# UNITED STATES PATENT AND TRADEMARK OFFICE

10/751,565

<b>Office Action Summary</b>	<b>Application No.</b> 10/751,565	<b>Applicant(s)</b> UEDA ET AL.	
	<b>Examiner</b> Henry M. Johnson, III	<b>Art Unit</b> 3739

**FIG. 1**

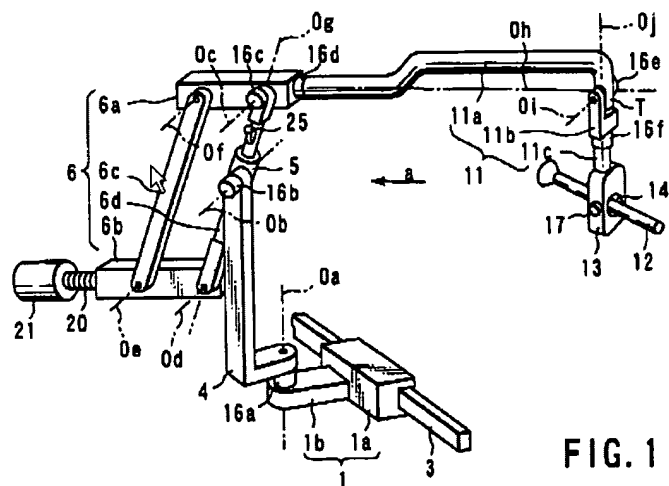
Shimmura et al. teach a medical instrument holding apparatus with a portion for holding an instrument (Fig. 1, #

14), a support arm (Fig. 1, # 11a), a base support (basal portion, Fig. 1, #s 3 & 4), a shaft coupled to the basal support (Fig. 1, # 5), the shaft forming part of a parallelogram moving (moving mechanism) structure (Fig. 1, # 6) with a counterweight (Fig. 1, # 21) to offset the weight of the support arm (Fig. 1, # 11a) and instrument. The mechanism is rotatable about axis Og (Fig. 1). Arm 6a is clearly shorter than arm 6c of the parallelogram. A ball joint is disclosed that connects the moving portion to an instrument support portion (Fig. 7, #16h). Since the center of gravity of the instrument and support depends on the instrument and the orientation, the ball joint is clearly capable of being oriented in any relation to the center of gravity. An operator may grasp any portion of the support and instrument elements.

(Fig. 1, #s 16a-16f), with an activating switch on the holding portion (paragraph 0059). A braking means is also disclosed for the ball joint (paragraph 0092). The instrument holding portion is interpreted is capable of being held by an operator and is coupled to the support arm by rotatable joints (Fig. 1, #s 16e & 16f). The upper portion of the parallelogram is shorter than the lower portion with the counterweight and either of the side arms. The counterweight is adjustable via screw threads (Fig. 1, # 20).

The apparatus of Shimmura et al. implicitly has centers of gravity, centers of inclination and forces exerted within the device based on the weights of the instrument and counterweights. Relative positions of apparatus components will vary as the instrument is positioned and can assume limitless configurations. The apparatus is therefore interpreted as capable of the position cited.
